Army and Navy Sustainable Transport Package – Partner Briefings

March 2022

Design changes

Baddow Road crossing

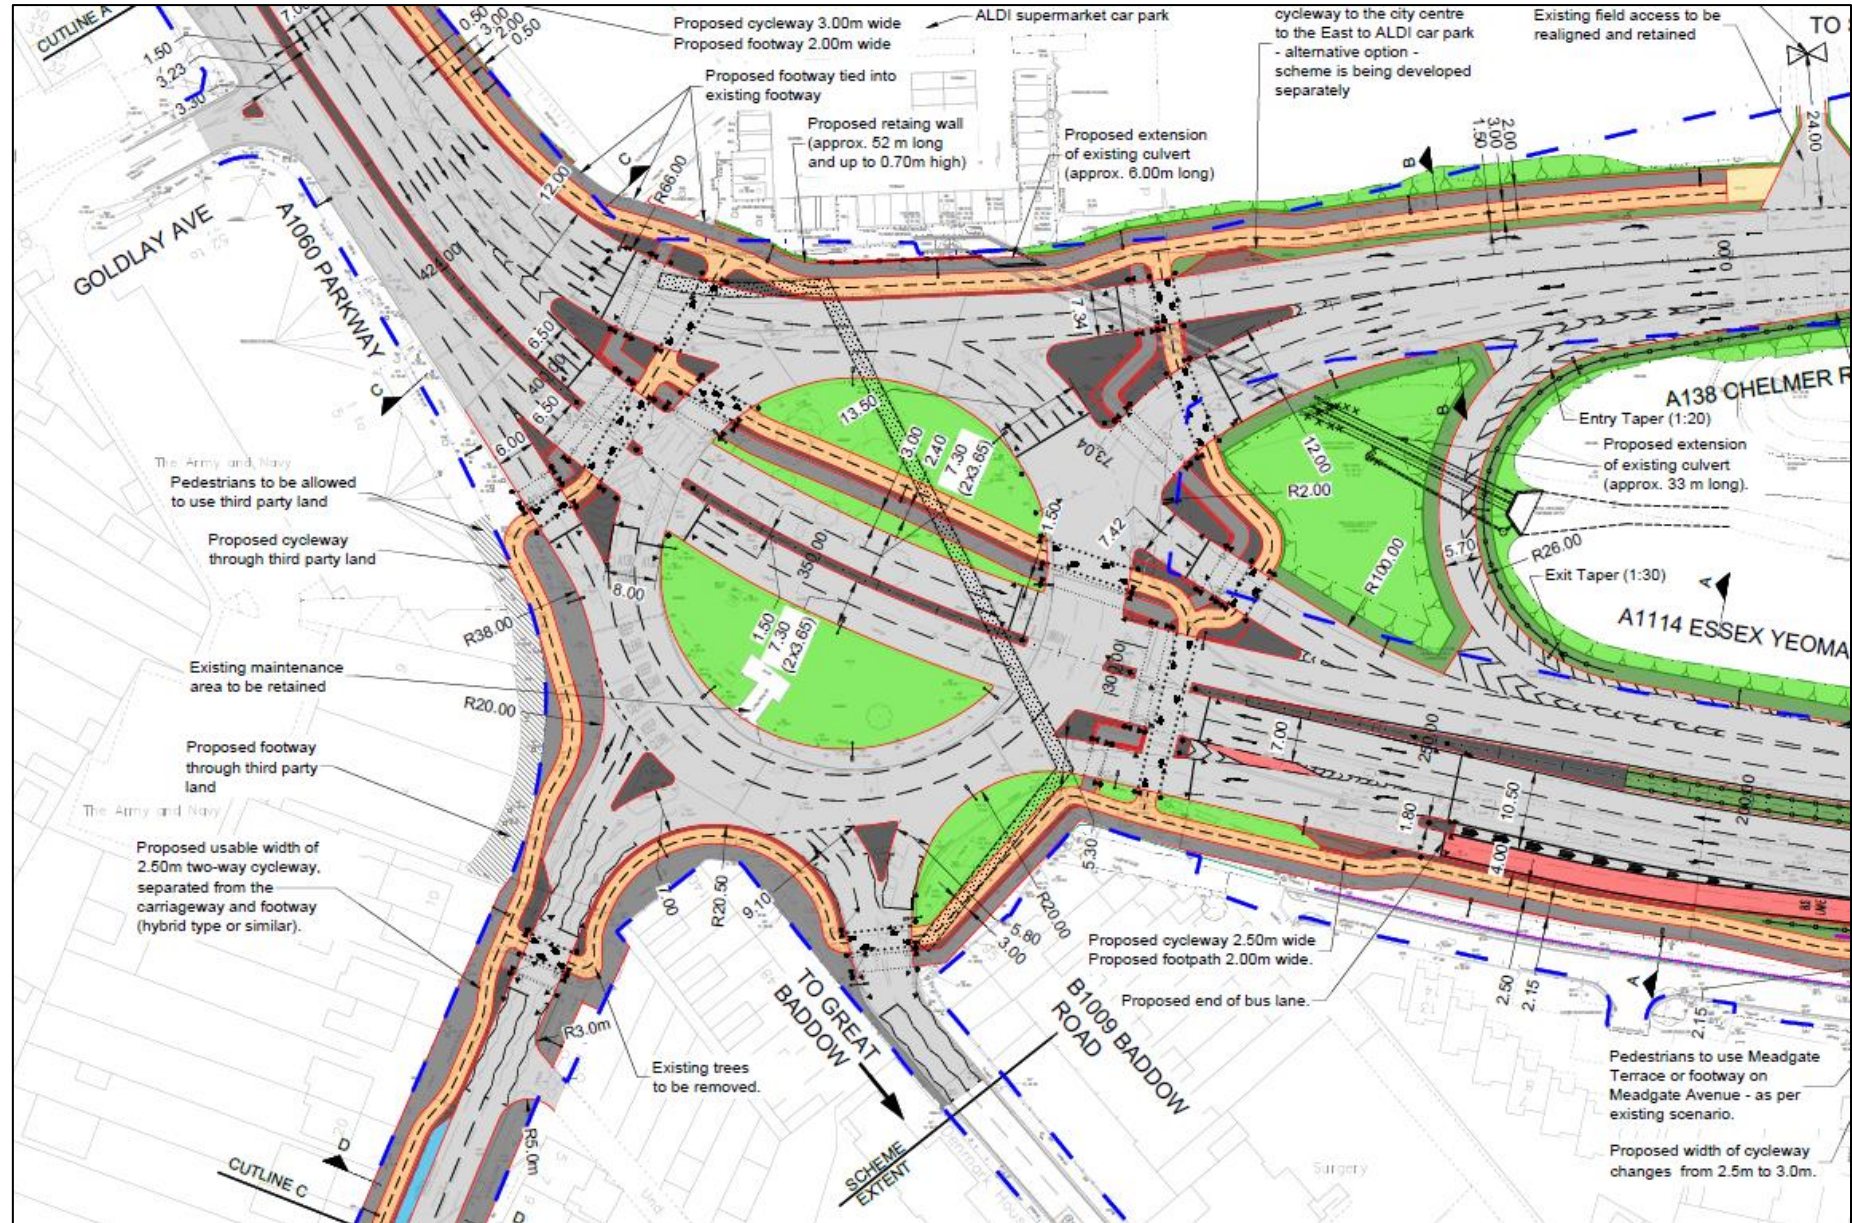
- Some concerns were raised during the consultation about the proposed zebra crossing on the Baddow Road arm of the junction, particularly regarding visibility and safety
- Design now amended to a signalised crossing
- Signal timings linked in with the rest of junction
- Reduced bus and car journey times on Baddow Road
